DRG NO 66/3

WS 66 MOODY '333'

SCALE 1" TO 1'-0" DRAWN ME/AMR DATE 25/3/81.

AMENDED 30/3/81. & 2/4/81.

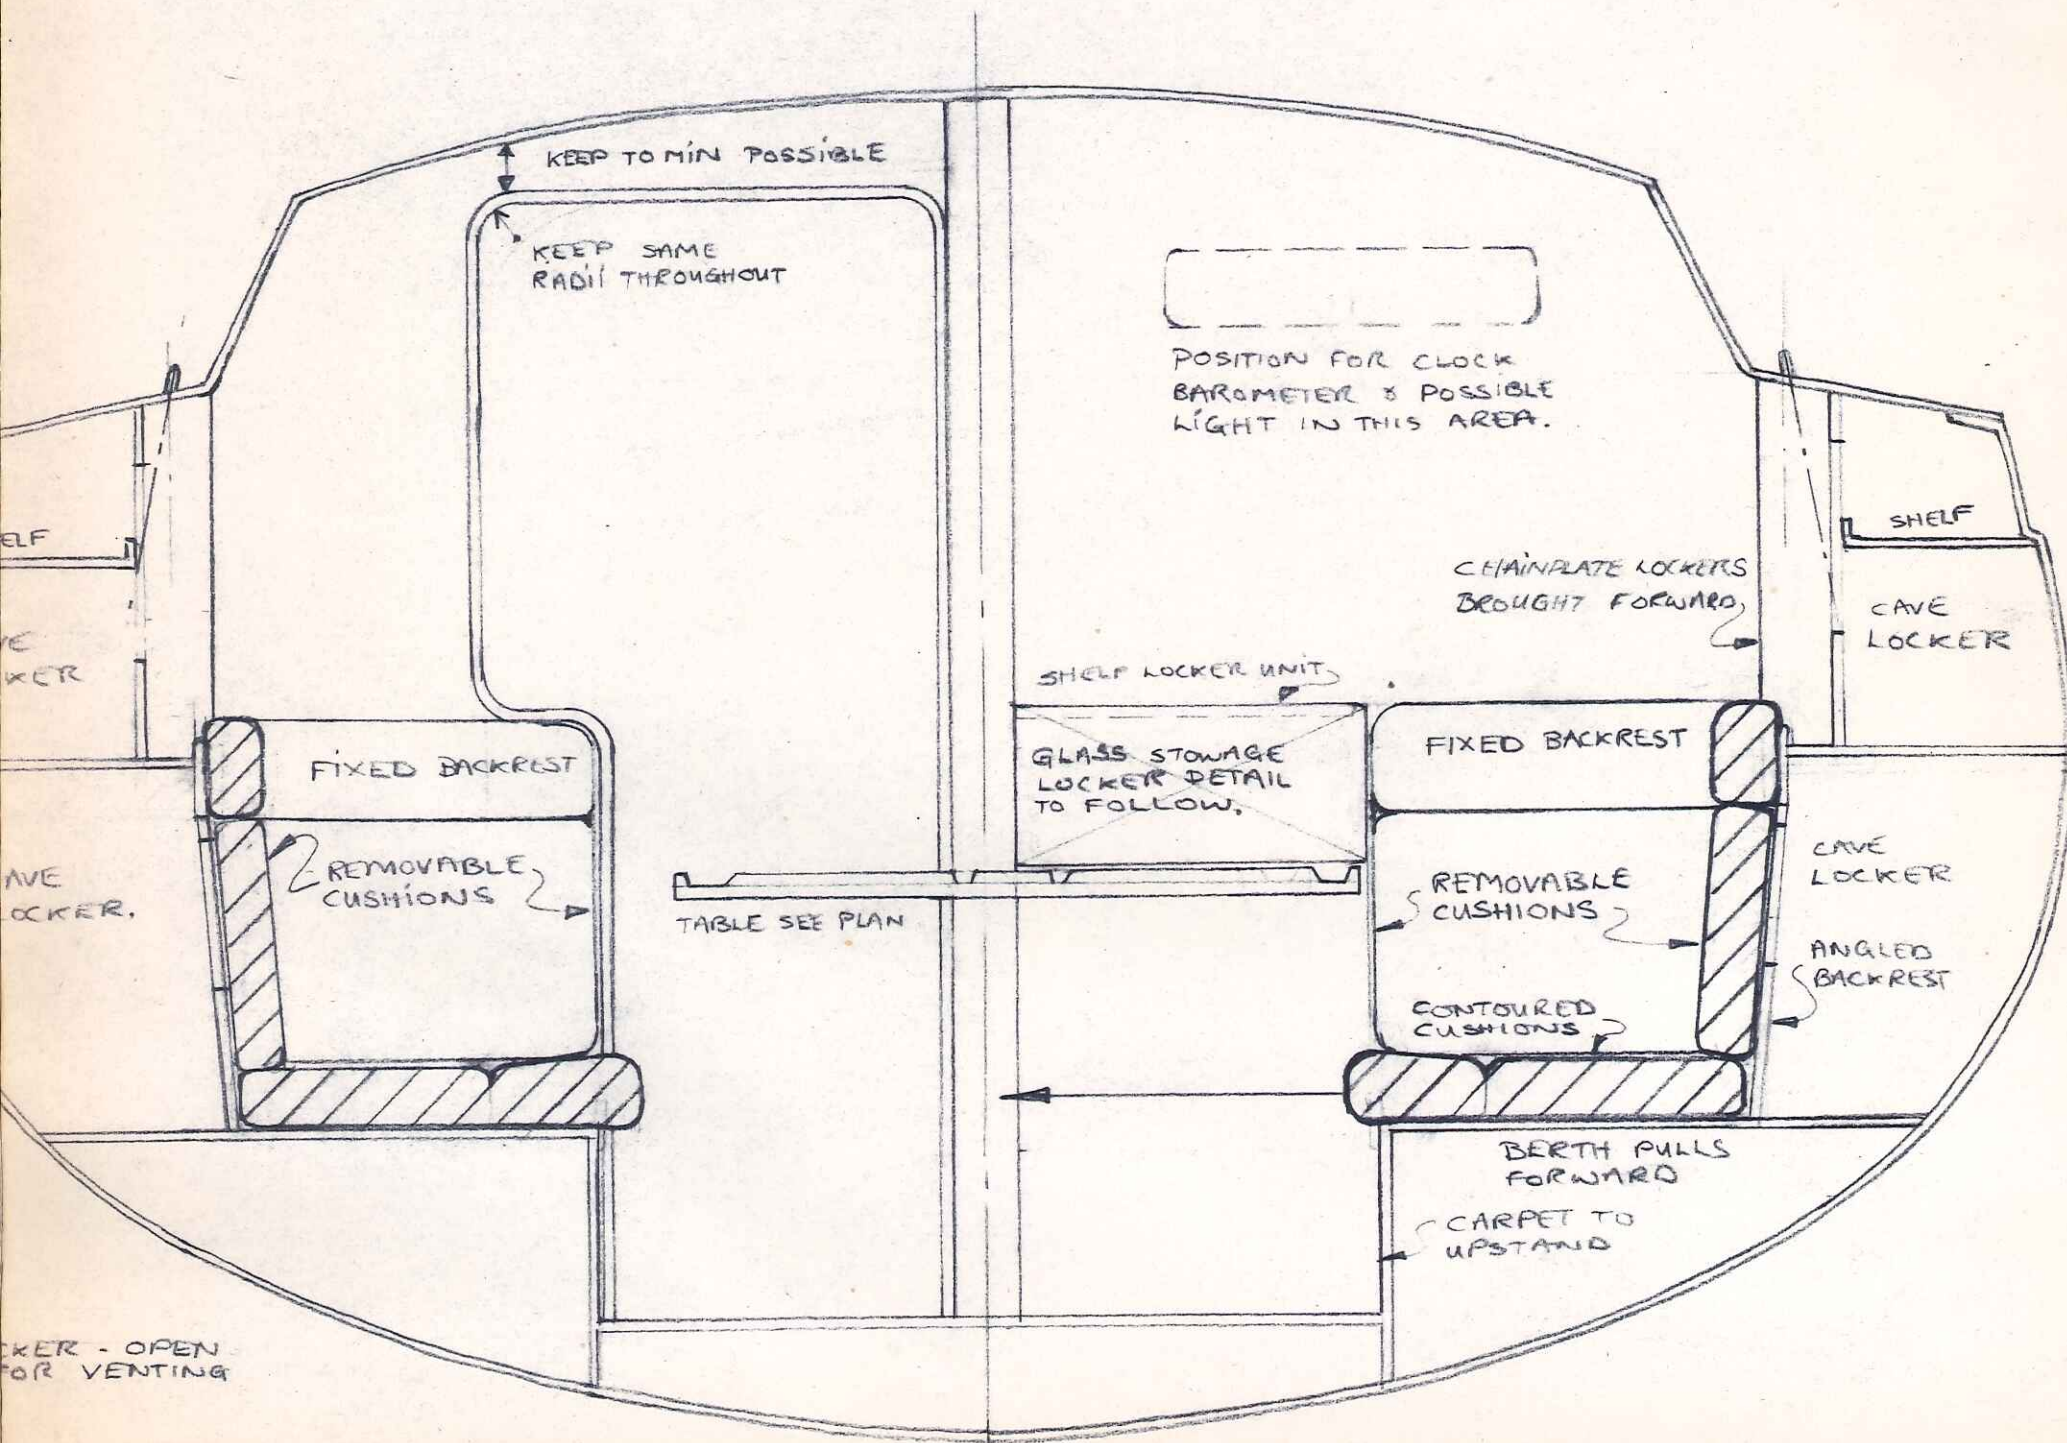
NOTE AMENDED COOKER LOCATION
 & REVISED DRAWER FRIDGE LAYOUT, WORKTOP
 FIDDLE POSITION RAISED

CHECK COOKER & POT
 CLEARANCES

LIFT UP & DROP DOWN COVER OVER
 COOKER TO MATCH WORKTOP
 NOT SUFFICIENT CLEARANCE FOR
 FOLDING COVER.

UPSTAND REDUCED TO CLEAR COOKER
